|   | 5        | 10-21-25      |
| <b>STANDARD ROAD PLAN</b>   |          | <b>PV-507</b> |
| <b>MEDIAN CROSSOVER</b><br><b>(68.24' MEDIAN)</b><br><b>16' WIDE 1 LANE</b> |          |               |

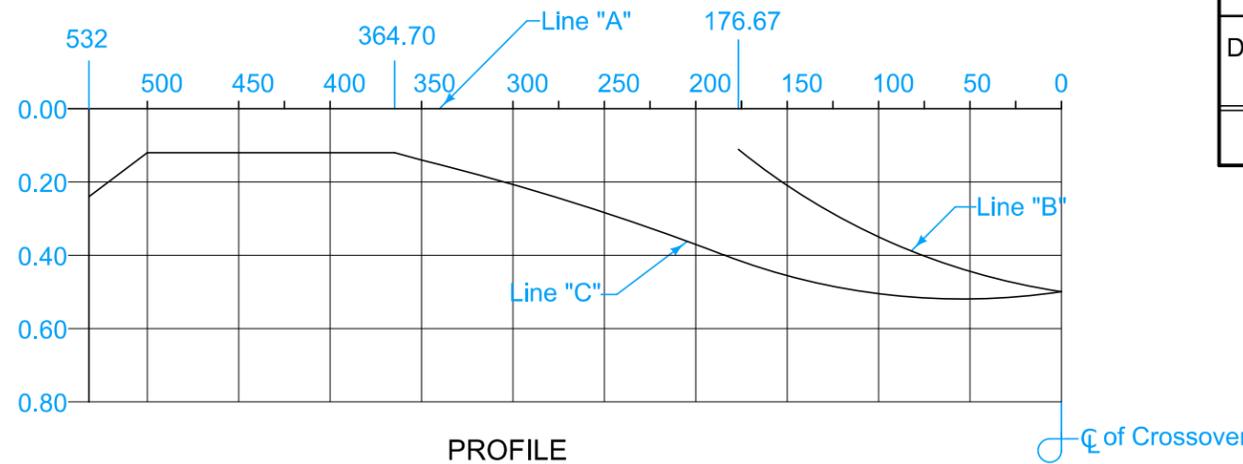
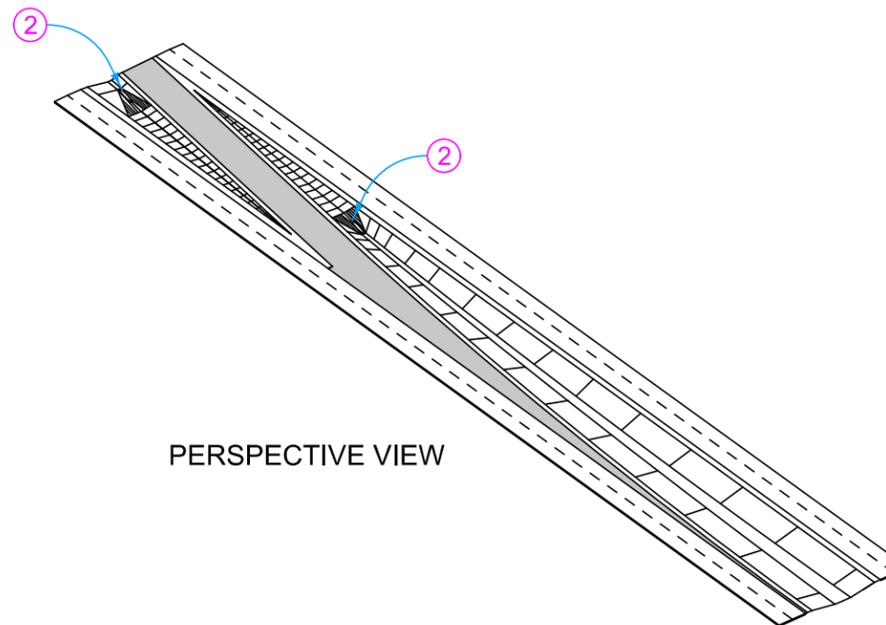
| REVISIONS: Changed 'KT-2' joint to 'BT-2' joint.                            |          | SHEET 1 of 1  |

- Detour Pavement options: 9" PCC or 12" HMA  
For joint details, see PV-101.
- ① Median crossover is symmetrical about centerline.
  - ② Median pipe for crossover. See DR-504.
  - ③ For PCC Detour Pavement, match existing roadway joints. 'CD' joints are required.
  - ④ 'BT-2' or 'L-2' joint if mainline pavement is new construction. Bend bars out. 'BT-3' joint if mainline pavement is existing. 'B' joint if Detour Pavement is HMA.
